**FINAL DRAINAGE REPORT
FOR
SADDLEHORN RANCH – FILING 5 EARLY GRADING**

**September 1, 2022
Project No. 25142.07**

El Paso County PCD File No.:
EGPXXX
EGP226

DP02 Early Grading Design Point 1.0 (Q5=0.2 cfs Q100=6.4 cfs)

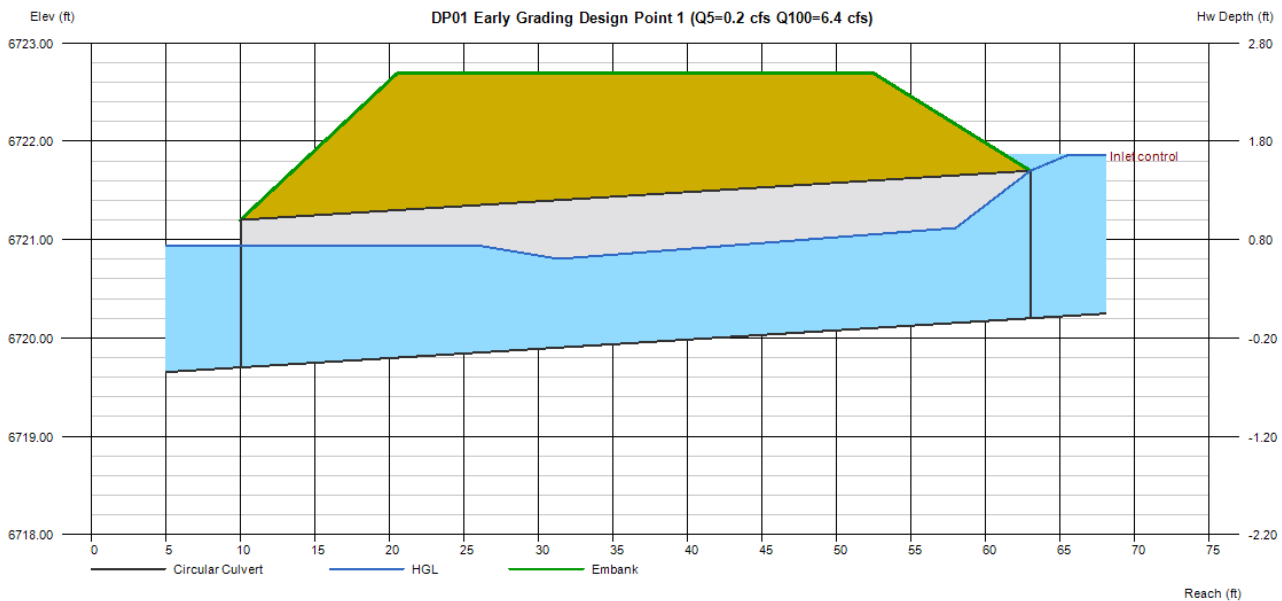
Flows do not match hydrology spreadsheet for DP 1.0. Please update sheet with flows shown on hydrology spreadsheet (0.3 & 11.4 cfs)

Addressed

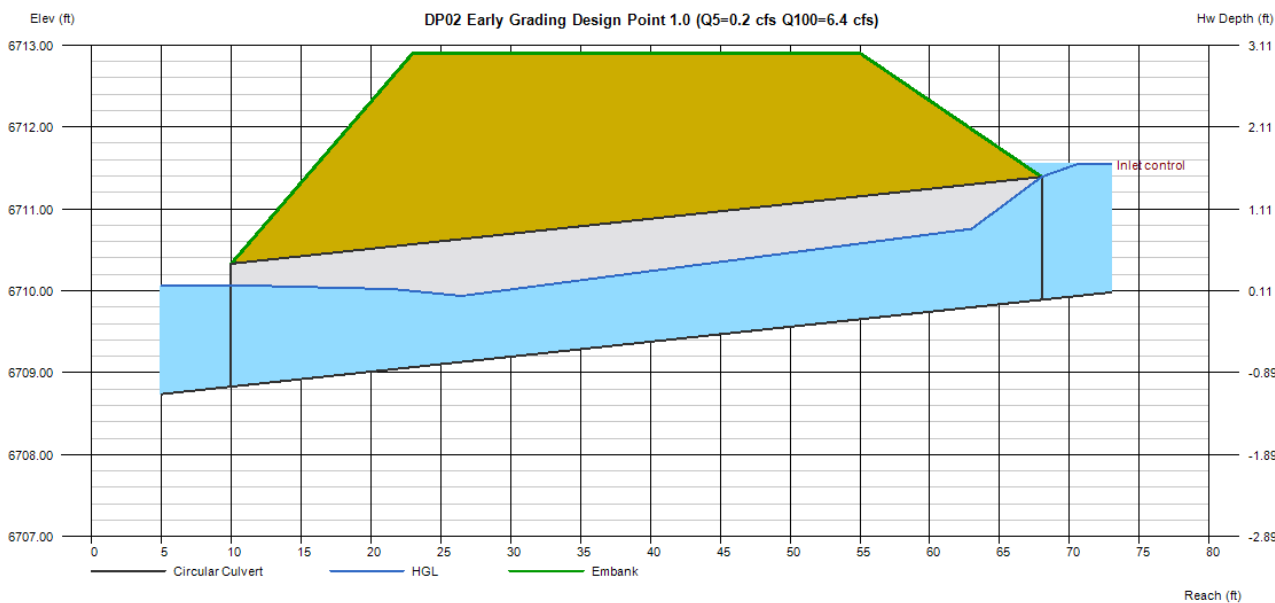
Flows do not match hydrology spreadsheet for DP 1.1. Please update sheet with flows shown on hydrology spreadsheet (0.4 & 15.2 cfs)

MS4 PERMIT EXCLUSION AREAS
SADDLEHORN RANCH FILING 5
JOB NO. 25142.07
9/1/2022
SHEET 1 OF 1

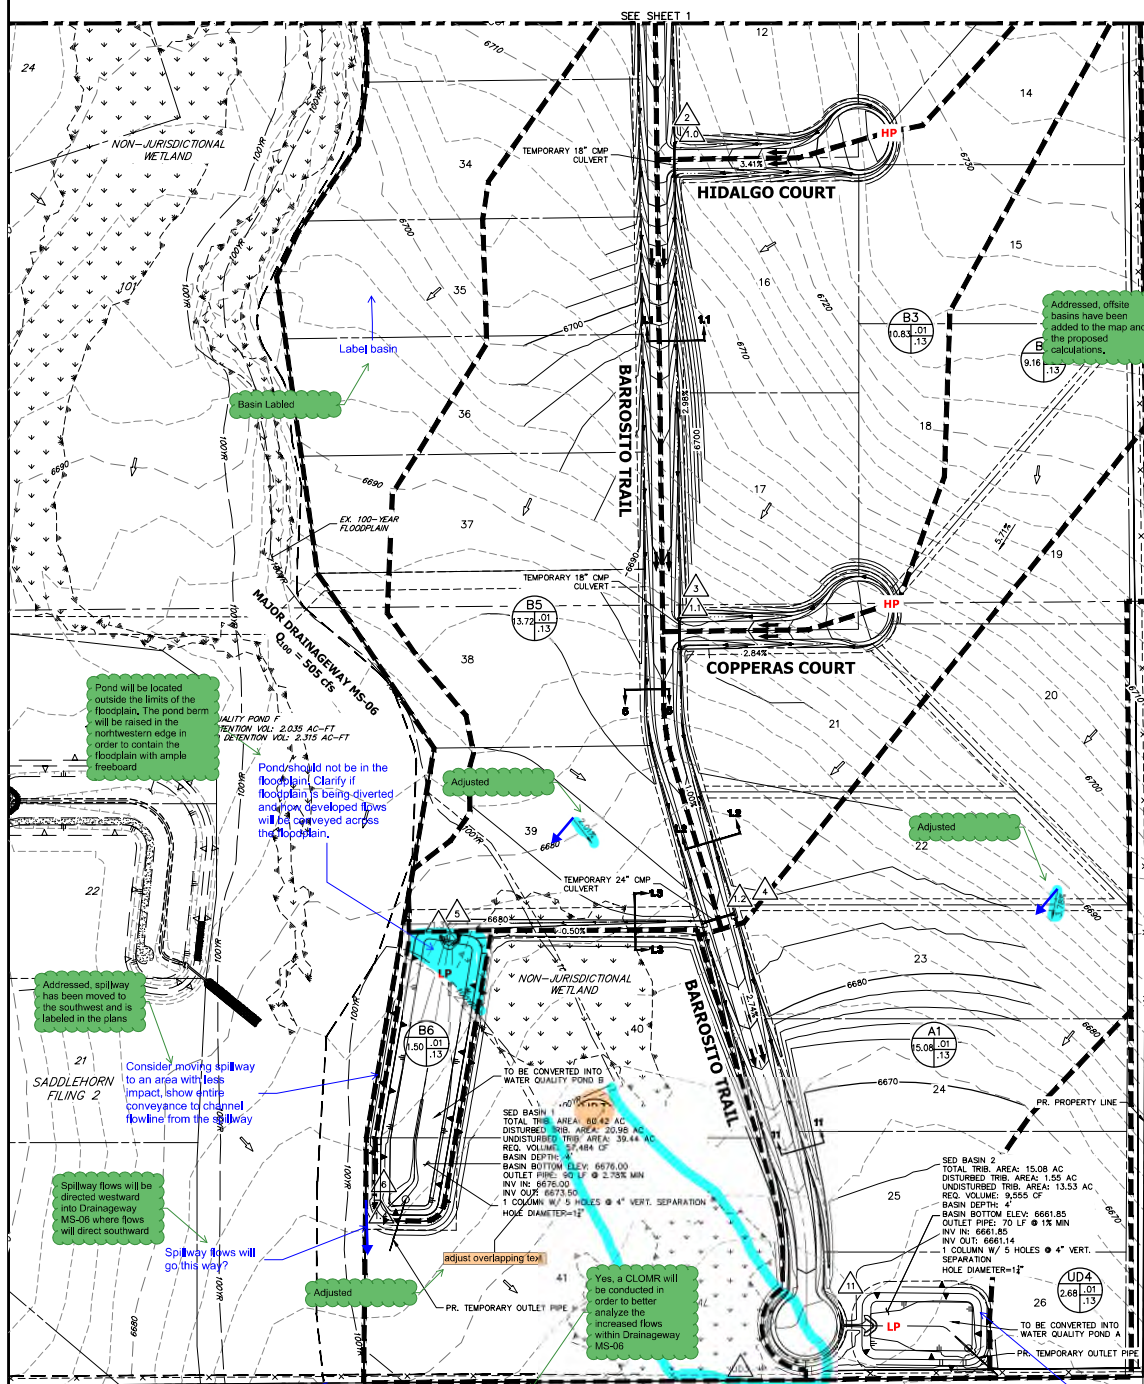
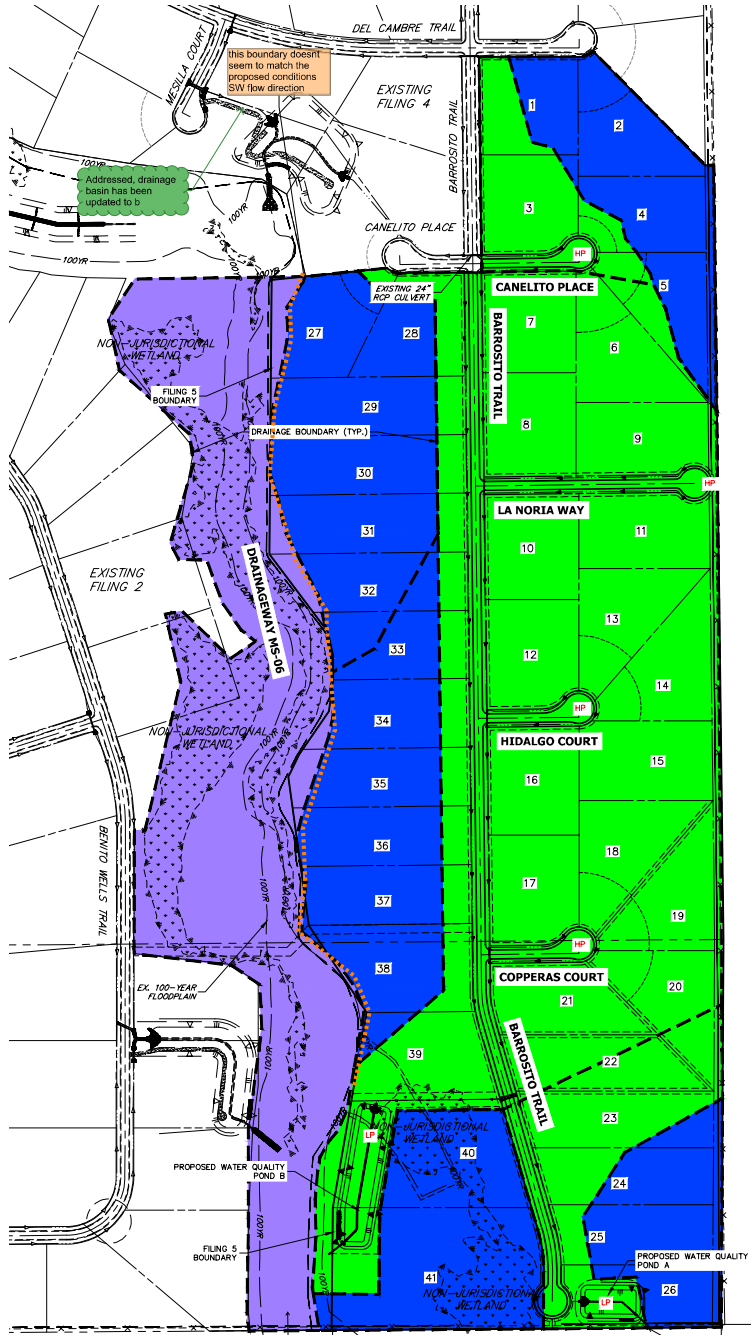
show offsite discharge path from outlet to drainageway

Addressed, spillway flow pathways added to plan set

SADDLEHORN RANCH - FILING 5 EXISTING CONDITIONS MAP

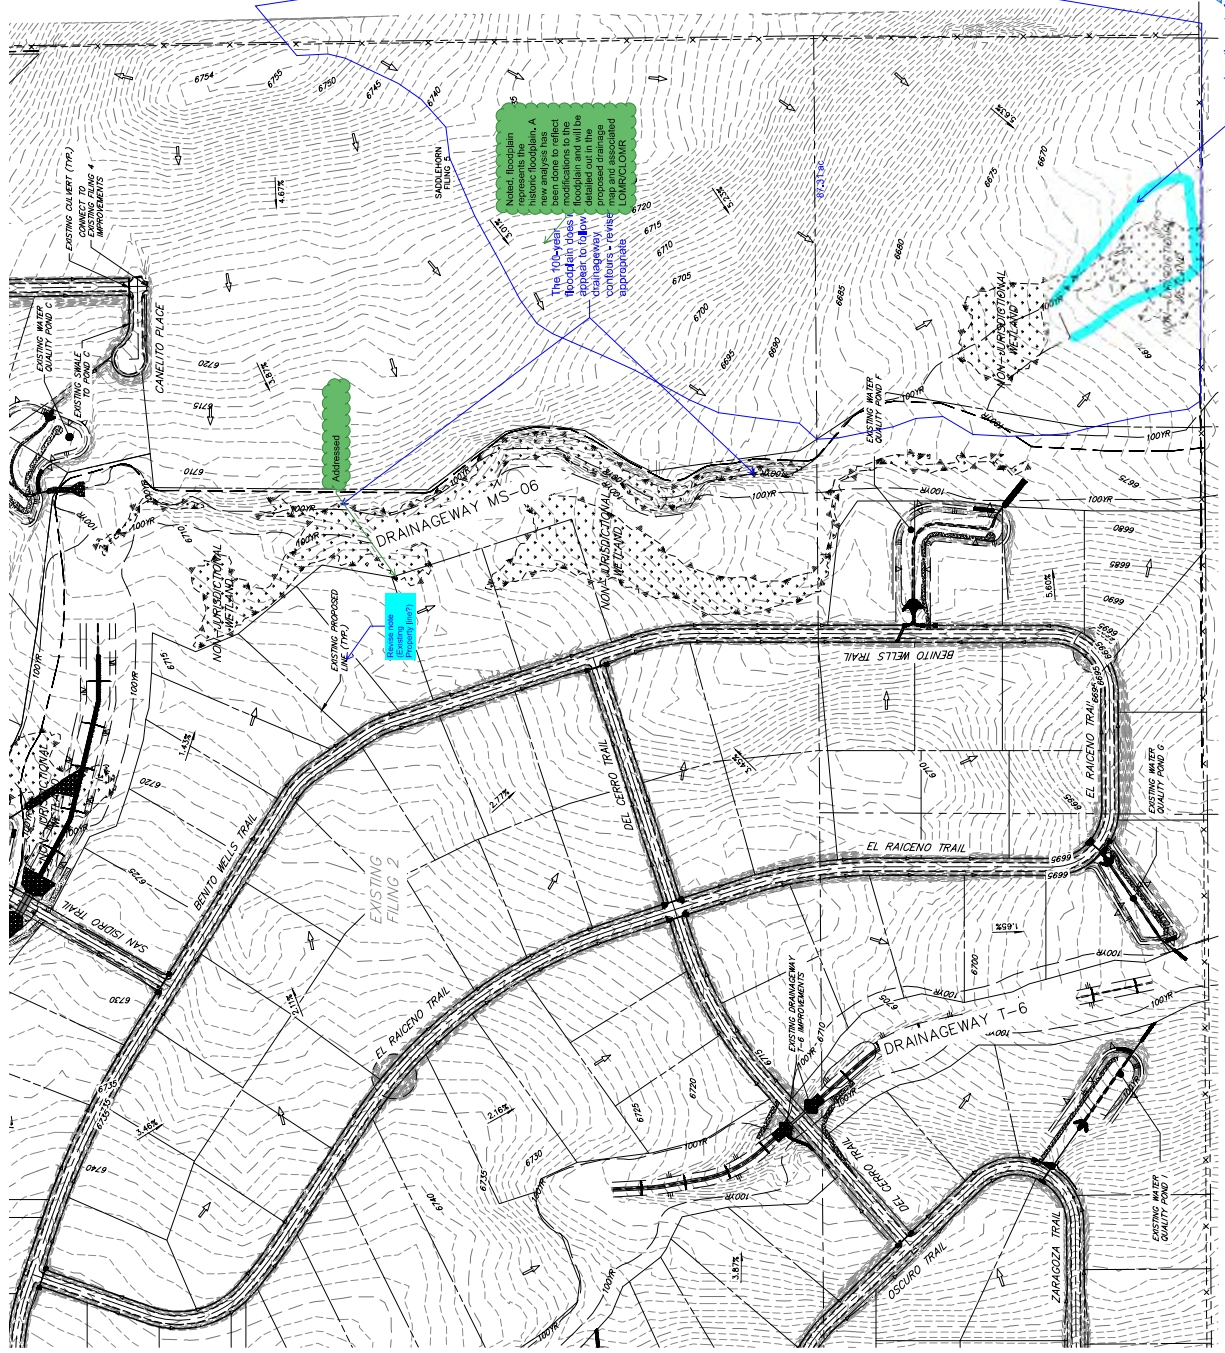
Provide sub-basins, design points, flows, etc, for comparison to developed condition design points

show the rest of the 100-year floodplain to the property line

Addressed: existing condition basin that will be treated by the proposed detention pond. The proposed detention pond will be located on the east side of the channel. The proposed detention pond will be located on the east side of the channel. The proposed detention pond will be located on the east side of the channel.
